Planning Application (LPA reference: 2024/3123/P) proposing the 'Erection of single-storey roof extension to provide 2 new residential (Class C3) units' at: Glebe House, 15 Fitzroy Mews, London, W1T 6DP.

DLP Planning have been instructed by the leaseholders of Glebe House to lodge a formal objection to Planning Application 2024/3123/P, submitted by Works Architecture on behalf of John Broomfield. The Application seeks permission for the: *'Erection of an additional storey to create 2 residential dwellings.'*

Figure 3: Dwg No. e-100, with two red lines inserted to compare the height of neighbouring buildings.

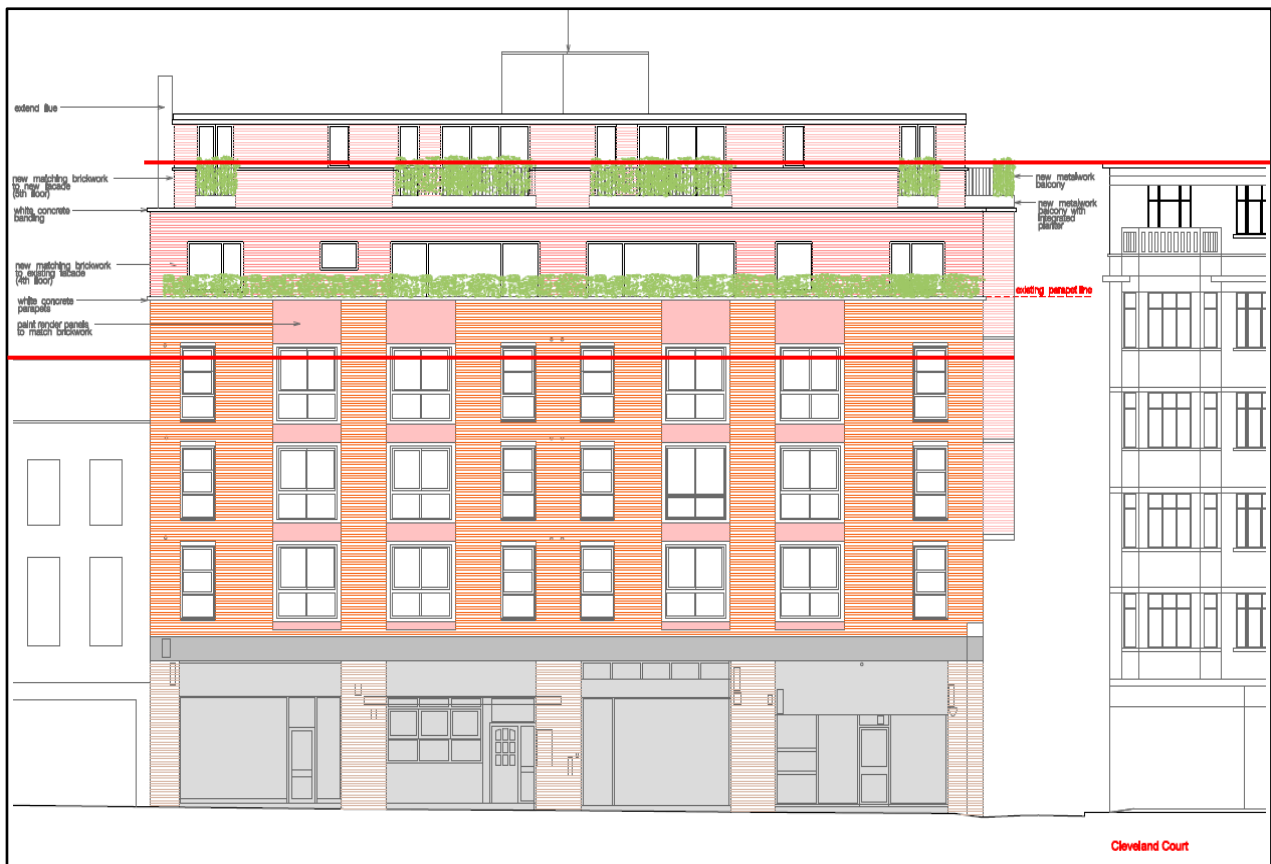
Drawing No. e-100 (Figure 3), shows the proposed front elevation of Glebe House which fronts Cleveland Street and includes the adjacent/adjoining terraces located directly north and south. Annotations have been inserted to indicate the height of these existing buildings in contrast to Glebe House after the proposed works have been completed. It is clear that the additional storey would result in an overly dominant building with no positive relationship with nearby buildings, particularly the adjoining terrace to the north (100-126 Cleveland Street).

By not providing dimensions on the submitted plans, the Applicant has made it difficult for the Local Planning Authority and members of the public with an interest in the proposal, to accurately understand the scale of the development. This is further exacerbated by the Applicants failure to acknowledge the difference in site levels between Fitzroy Mews to the east and Cleveland St to the west. No topographic survey was included in the planning application nor have site levels been included in the submitted plans.

Figure 4: Dwg No. e-103, with a red line inserted to show the difference in height between 4-7 Fitzroy Mews and Glebe House.

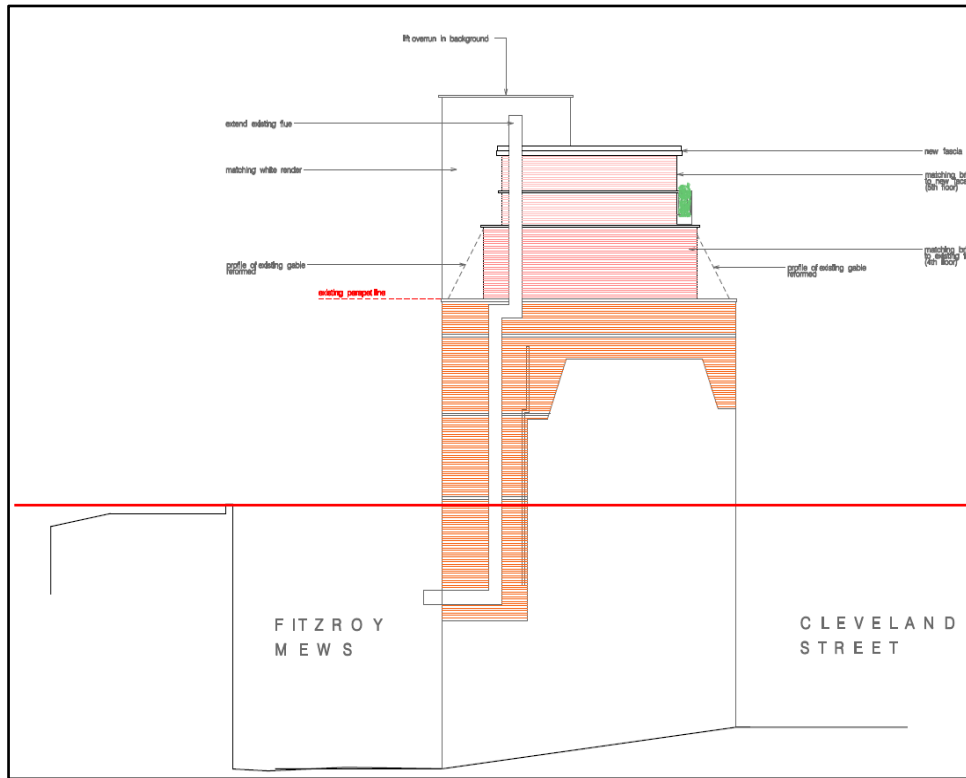
Notwithstanding, measurements of the submitted plans using the scales provided, indicates that there is an approximate 1.8 m difference between the two frontages, therefore the units located directly opposite Glebe House within the Mews (4 – 7 Fitzroy Mews) sit considerably lower than the Glebe House. The mews have an overall height of 8.5 m, should the proposal be approved, the eastern elevation of Glebe House would measure to be 22 m in height from Fitzroy Mews and dominate over 4-7 Fitzroy Mews by approximately 13.5 m as shown in Figure 4 below.

Overall, the Applicant has failed to articulate the full scale of the development and the significant negative impact this will have on the relationship between Glebe House and the neighbouring properties both along Cleveland Road and within the Mews.
